PLAN COMMISSION MEETING AGENDA

TUESDAY, February 25, 2014
AT 6:00 P.M.

PROJECT: Sign and Light Plan Review – Drexel Town Square

PROJECT: Site Plan Review – Four Points by Sheraton

FIGURE 4a. BUILD-TO-ZONE

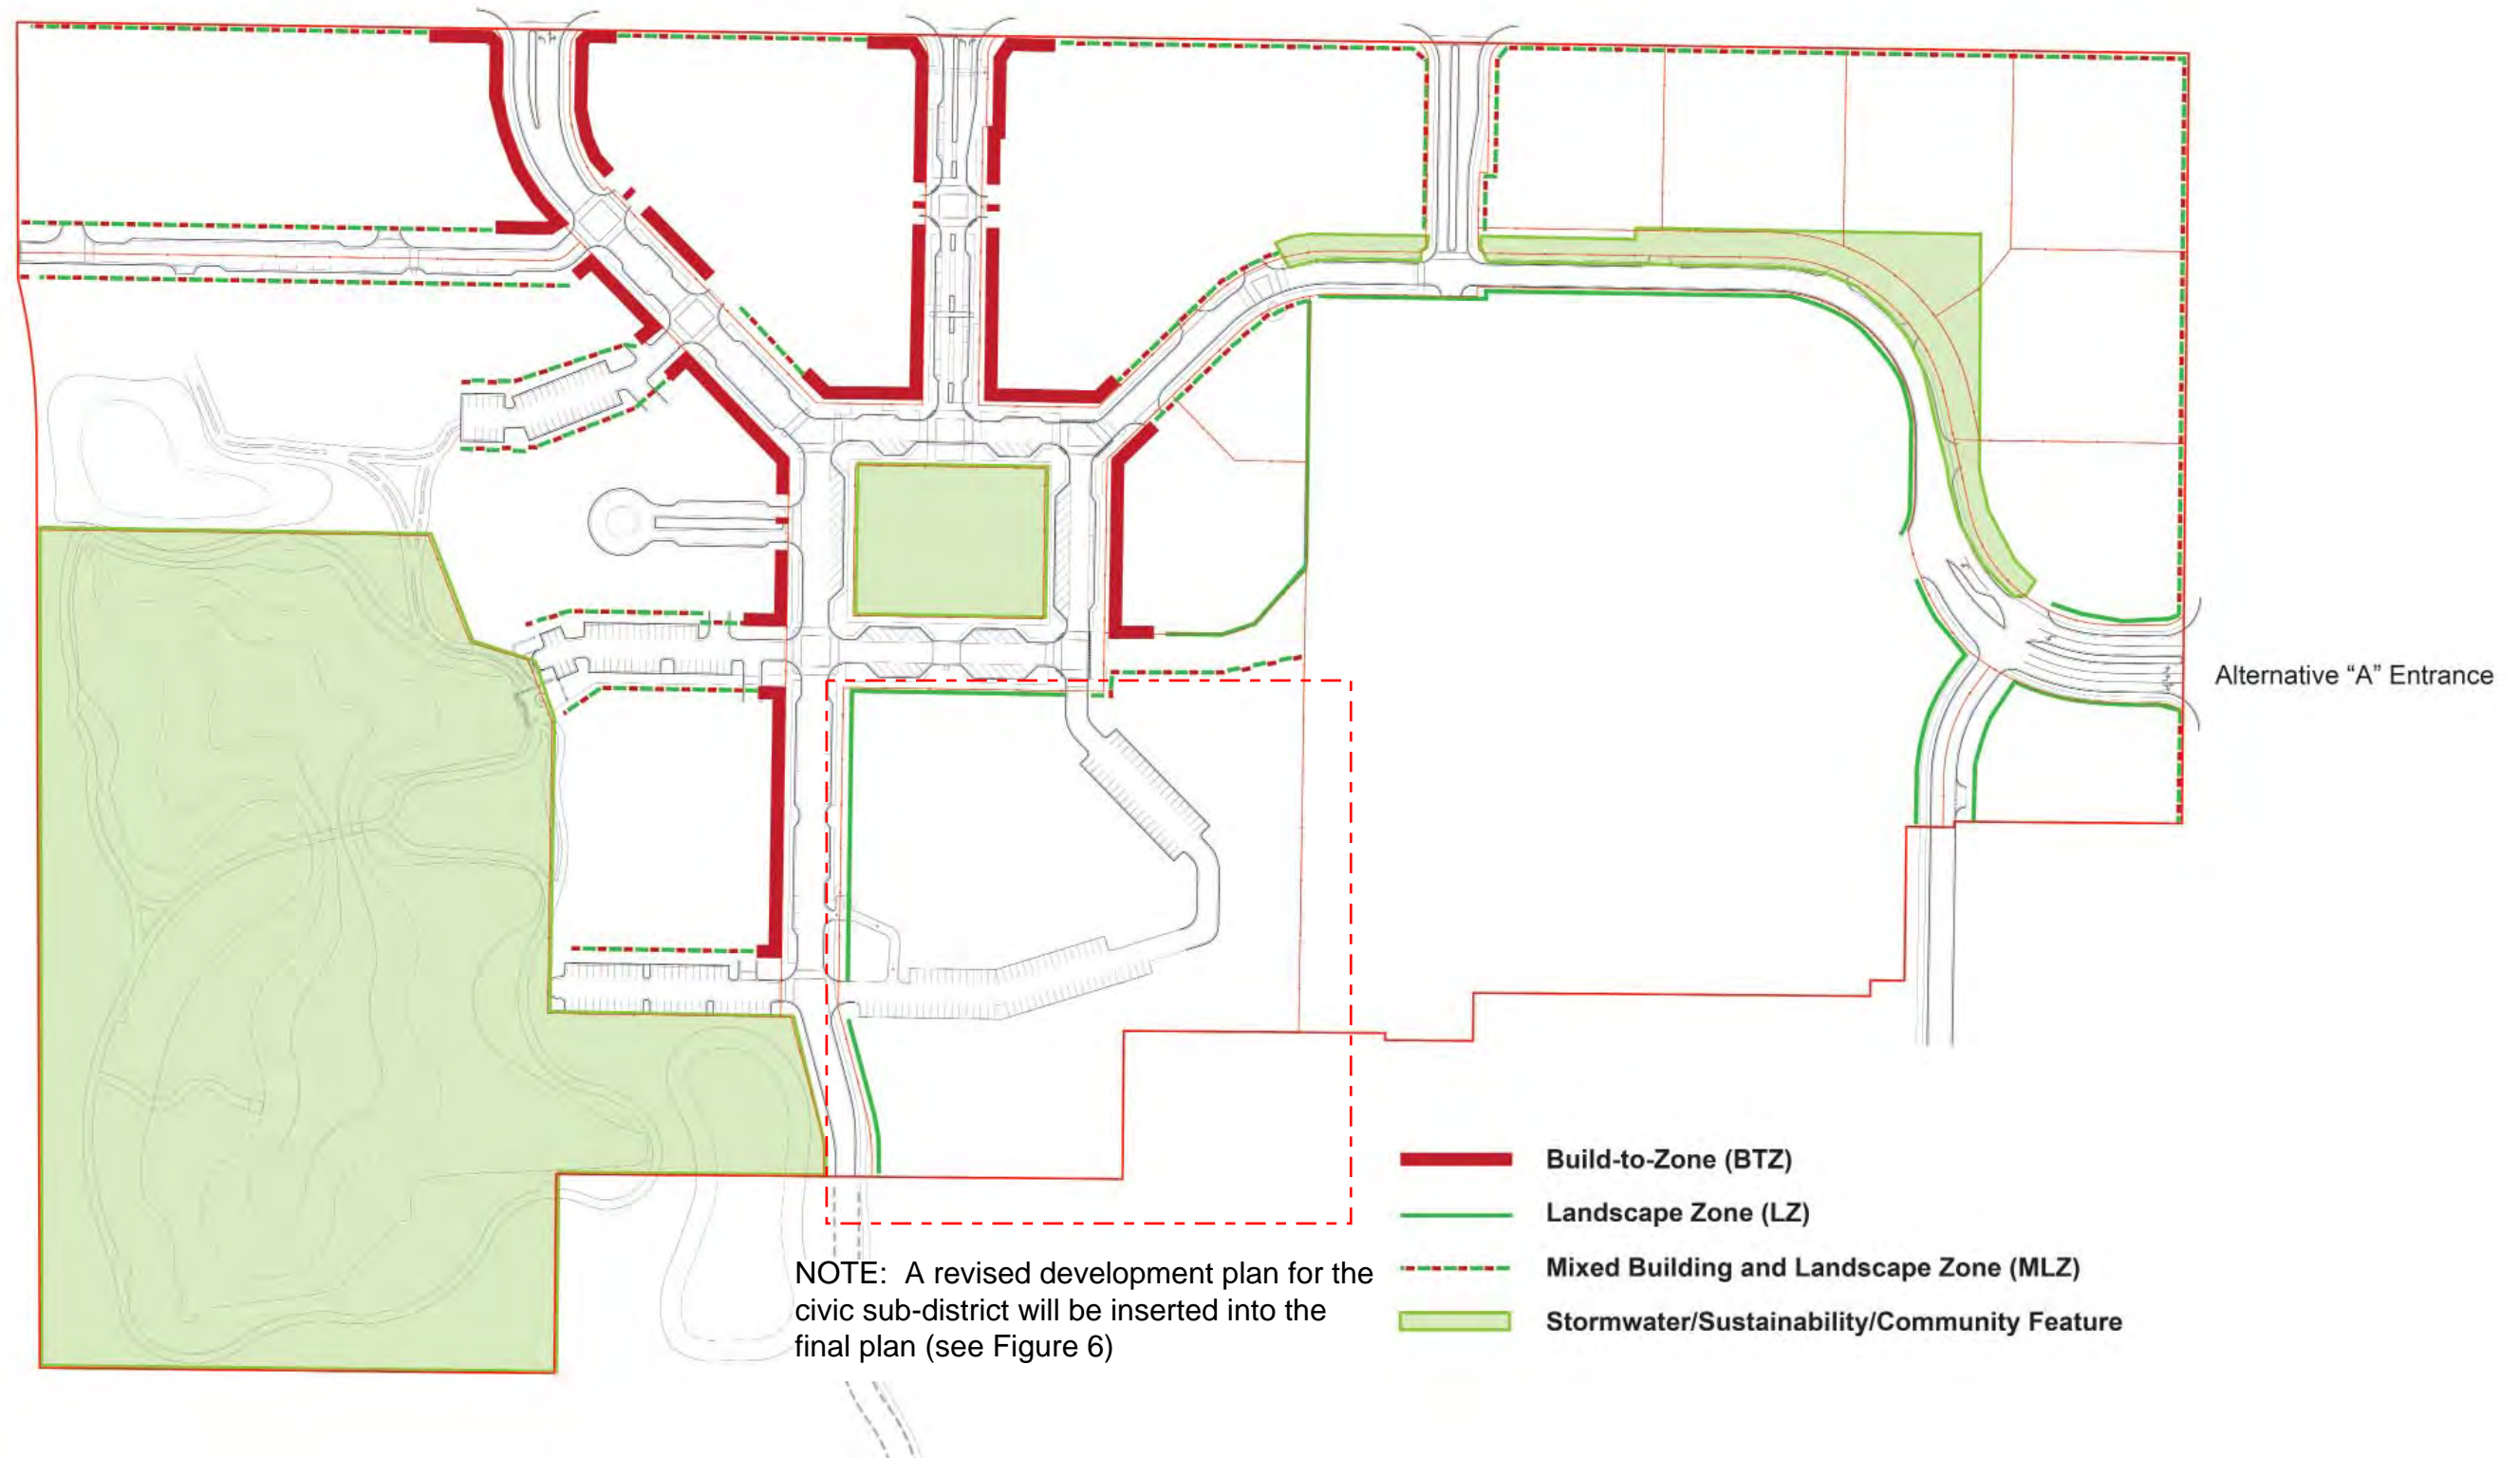
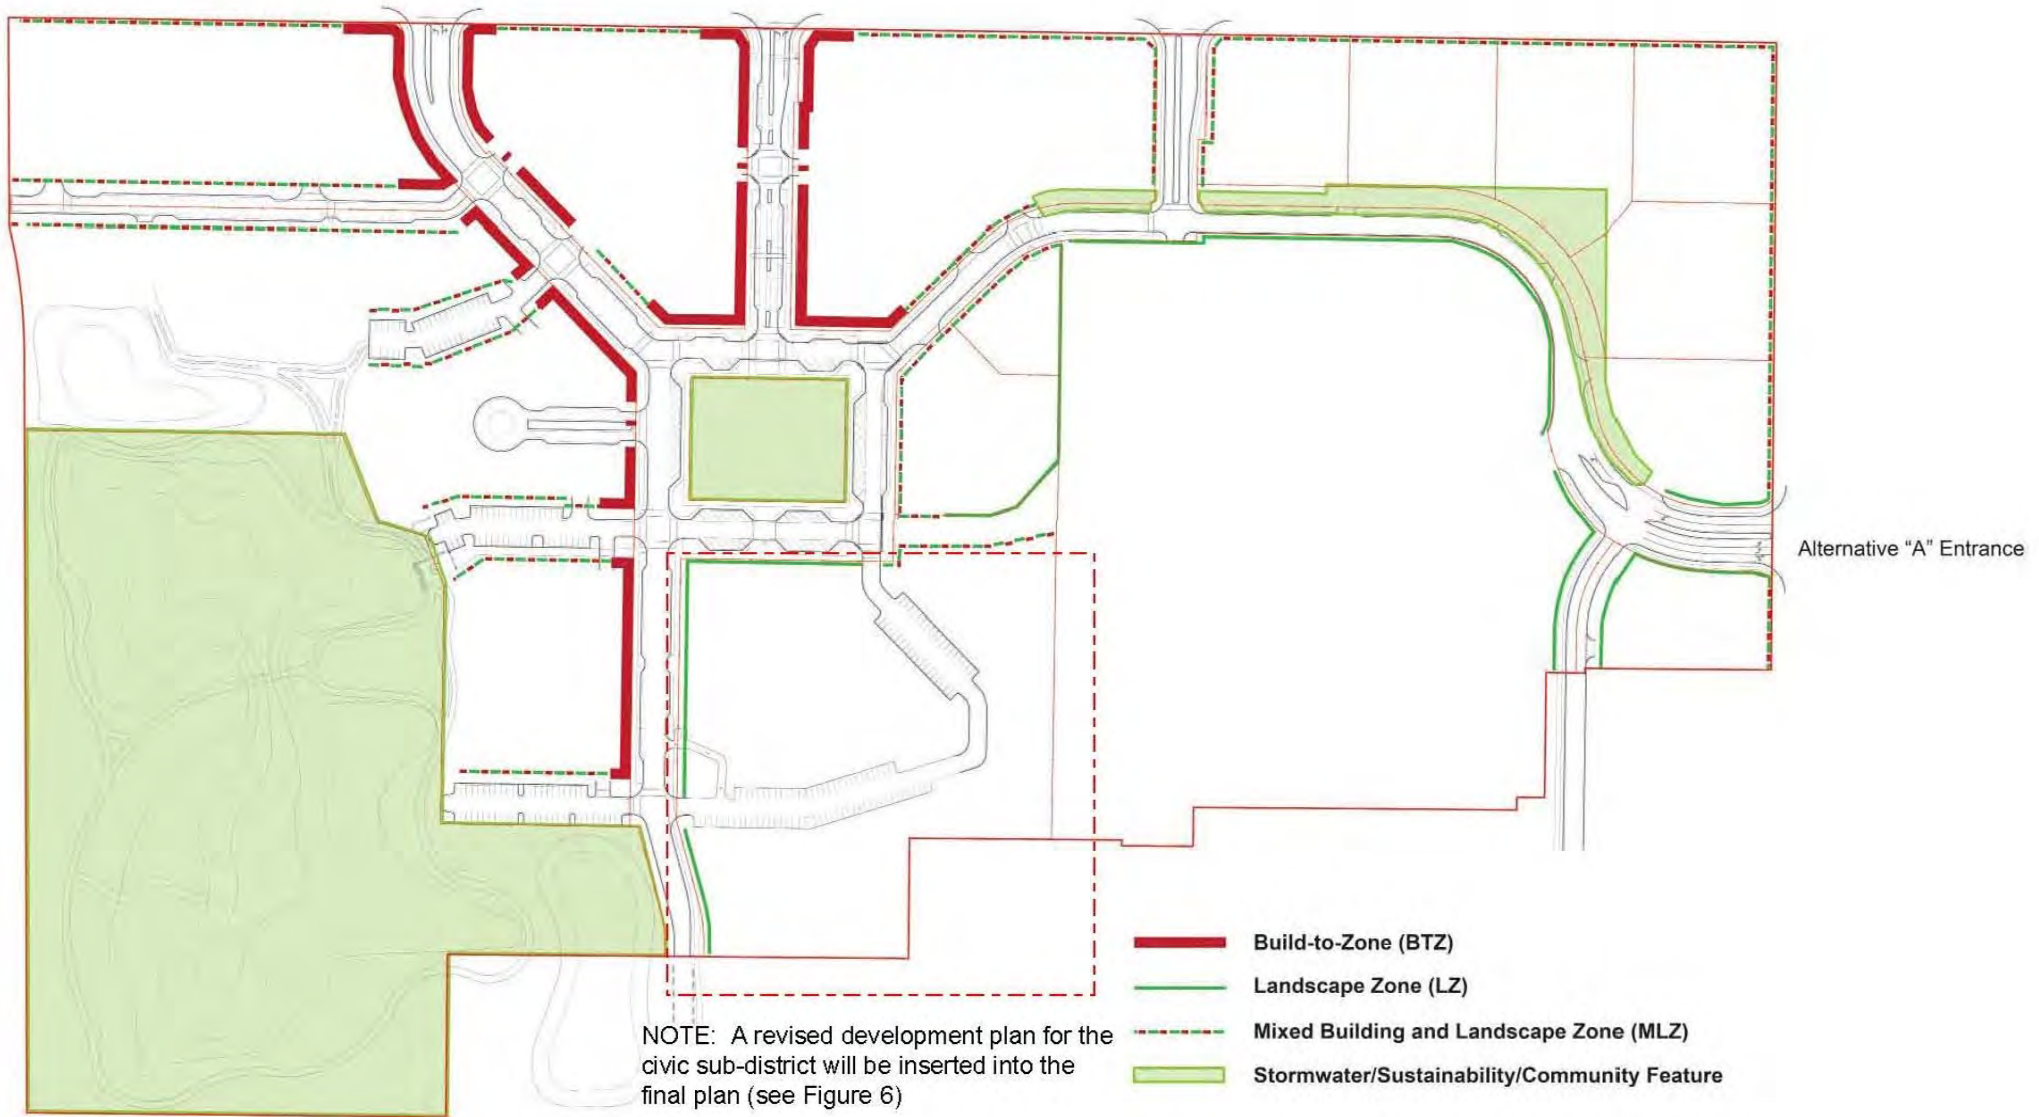
Commentary: One West Drexel, LLC, the City of Oak Creek, and Four Points by Sheraton are requesting approval of an amendment to the existing Drexel Town Square Mixed Use Planned Development District General Development Plan and Regulating Plan (“the Plan”). The proposed amendment involves the location of the build-to-zone in Figures 4a and 4b of the Plan.

The proposal is to replace the build-to zone (BTZ) along the east side of Market Street with a mixed building and landscaping zone (MLZ). A mixed building and landscaping zone is described in the Plan as an area “in which it is difficult to prescribe the precise locations of buildings on the lot...In such circumstances, the zone along the outer perimeter of the lot, abutting the public right-of-way, should be a combination of a build-to-zone and a landscape zone.” The change will allow flexibility in the development of the hotel property to be consistent with both the hotel’s design requirements and the goals of the DTSMUPDD. No other changes to the Plan are proposed.

STAFF RECOMMENDATION: That the Plan Commission recommends to the Common Council that Figures 4a and 4b in the Drexel Town Square Mixed Use Planned Development District General Development Plan and Regulating Plan be amended to replace the build-to-zone (BTZ) along the east side of Market Street with a mixed building and landscaping zone (MLZ), following a public hearing.
